# ACCESS ASSESSMENT REPORT

*21 Oaks Ave, Dee Why NSW*

Project Number: 118613

Date: 6 March 2024

Bin Room

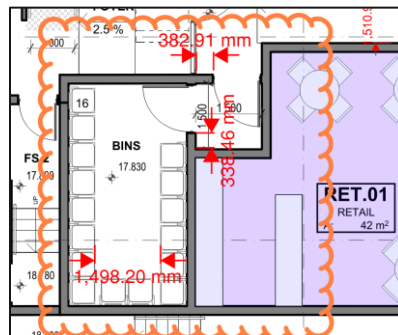
- Further design development is required at the two (2) doorways providing access to the Bin Room where doorway circulation space in line with AS1428.1-2009 is not provided i.e. latch-side clearance and Length. It is recommended that access directly from the Foyer is considered that to assist in achieving compliant circulation space with AS1428.1-2009.

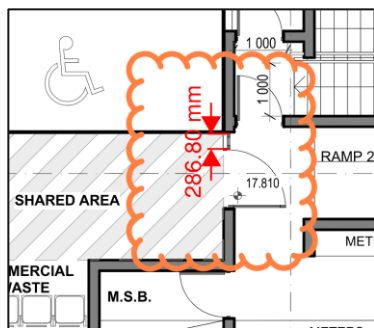
- Further design development is required at the doorway (both approaches) providing access from the Retail accessible parking bay to ensure 510mm 530mm latch-side clearance is provided for the full 1450mm (L) as per Figure 31(d) and (h) of AS1428.1-2009.

Level 01 Storage Room

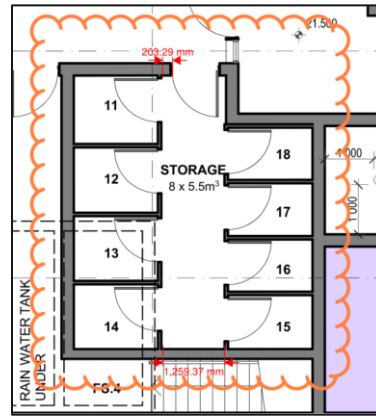
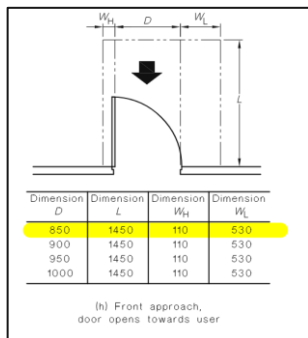
- Further design development is required at the entrance doorway of each Storage Room noted on Level 01 to provide compliant doorway circulation space internally in line with Figure 31(h) and a turning space in line with Figure 5 of AS1428.1-2009 at the end of the accessway.

Commercial Terraces

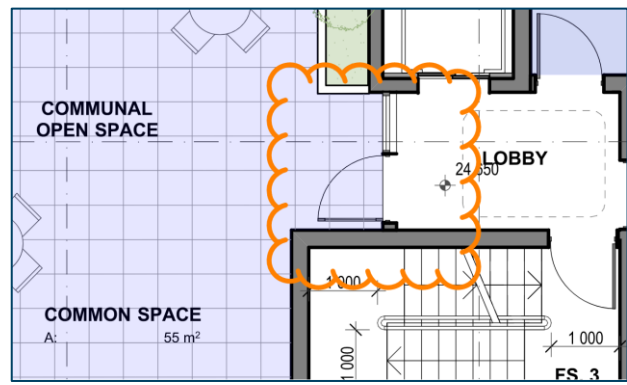
- Ensure doorway circulation space, latch-side clearance and an 850mm clear width opening is provided in line with AS1428.1-2009 at the two (2) doorways providing access to/from the Terrace within each Commercial tenancy, including a level transition at each doorway. A level transition is required at the doorway providing access to the Communal Open Space also.

Entry Walkway

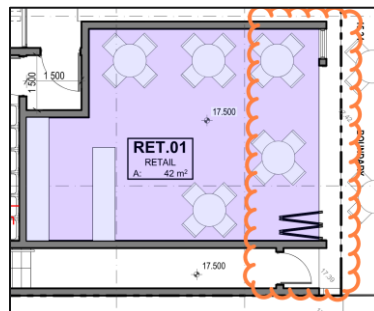
- D4D3(1)(a):** Further design development is required to provide compliant doorway circulation space at the top of the 1:20 'ramp' and a 1200mm x 1200mm landing at the base of the 'ramp' within the allotment boundary to comply with AS1428.1-2009. Note, a 1:20 gradient accessway is to be annotated as a 'walkway' in line with AS1428.1-2009, not a 'ramp'. Please refer to Point 1 under Part 2.6.1 and Point 20 of this Report.

**Non-Fire Isolated Stairway – Ground to Level 01**

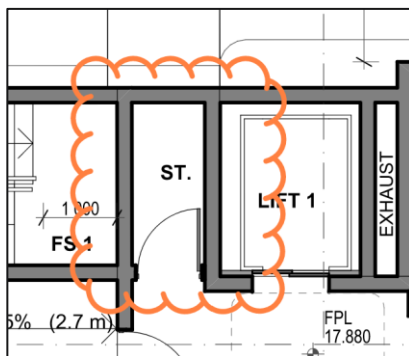
9. It is proposed that the non-fire isolated stairway providing access between Basement 1 and Ground Level will only consist of a single handrail in lieu of two (2) handrails and TGSIs as required by BCA D4D4(a)(ii) and Clause 11 of AS1428.1-2009 and shall be supported via a Performance Solution, subject to certifier's concurrence.

**Ground Level - Storage**

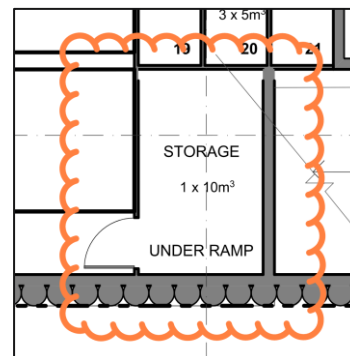
10. Pending confirmation of 2.10.3 of this Report (i.e. an area that is not feasible for accessibility exemption under BCA Clause D4D5) there can be additional requirement for provision of minimum 1540mm wide by 2070mm long clear wheelchair turning space within each space and increased door circulation space for the single swing entry doorway in line with AS1428.1-2009.

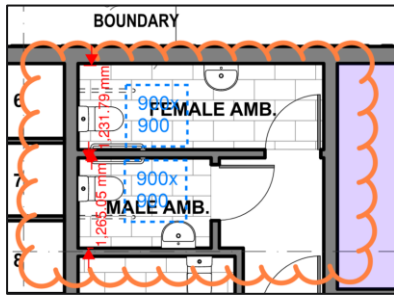
11. 900 x 900mm circulation space externally of the Male ambulant doorway and clear of airlock door swing as per Figure 34 (b) and Figure 53(B)(c) of AS1428.1-2009.

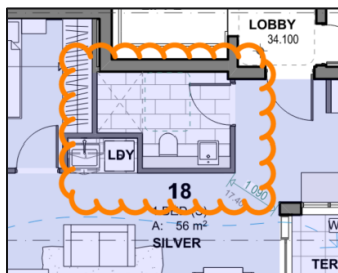
13. To satisfy Livable Housing Design Guidelines Silver Level Element 4, the WC pan is required to be positioned in the corner of the room when located in a combined bathroom. Unit 18, Unit 19 currently do not comply.

Ensure the required 900 x 1200mm circulation space forward of the WC pan is provided and clear of the door swing to satisfy Element 4 of LHDG. Currently not provided in Unit 08 and Unit 04.

Unit 08

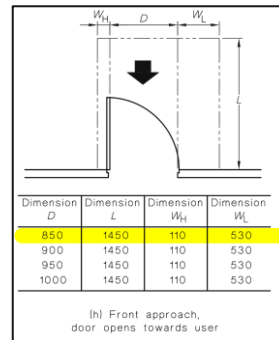
- 15. For Adaptable Unit 08, at the post-adaptation stage, doorway circulation space in line with AS1428.1-2009 is not provided due to the bed encroaching into the required space.

Unit 02

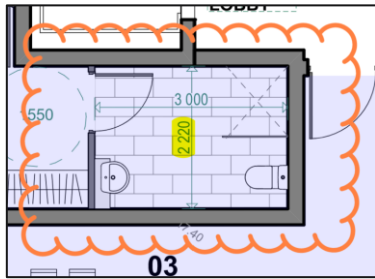
18. For all Adaptable units, at the post-adaptation stage, to satisfy AS4299-1995 in this current configuration, provide 2350mm wide x 2780mm long bathroom dimensions to satisfy the circulation space requirements of AS1428.1-2009.

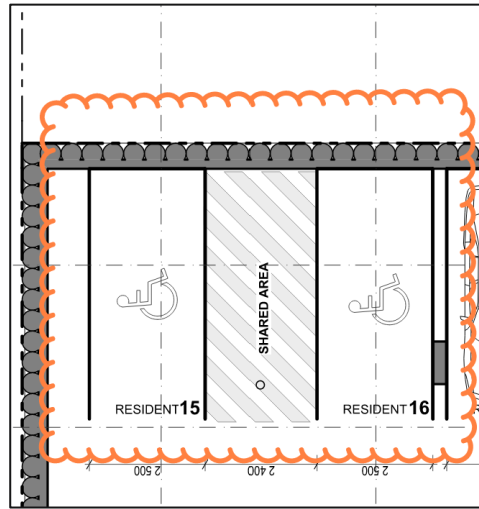
21. To satisfy Clause 3.7.3 of AS4299, one (1) car parking space per adaptable units shall have minimum dimensions as specified in Clause 3.7.2 of AS4299 i.e. 5400mm (length) x 380mm (width). Currently, only two (2) adaptable carparking spaces are proposed – Please provide one (1) additional carparking space to serve the number of adaptable SOUs proposed, being three (3).

The adaptable unit car parking spaces are currently designed to AS2890.6-2009, while permissible, it is strongly recommended that AS4299-1995 is applied where a 3800mm wide x 5400mm length space is required. Ensure a 2.5m min vertical clearance is provided above the space. The proposed allocation i.e. Resident 15 and 16 does not reflect the adaptable unit number as per the general arrangement plans which are SOU 02, 16 and 20.
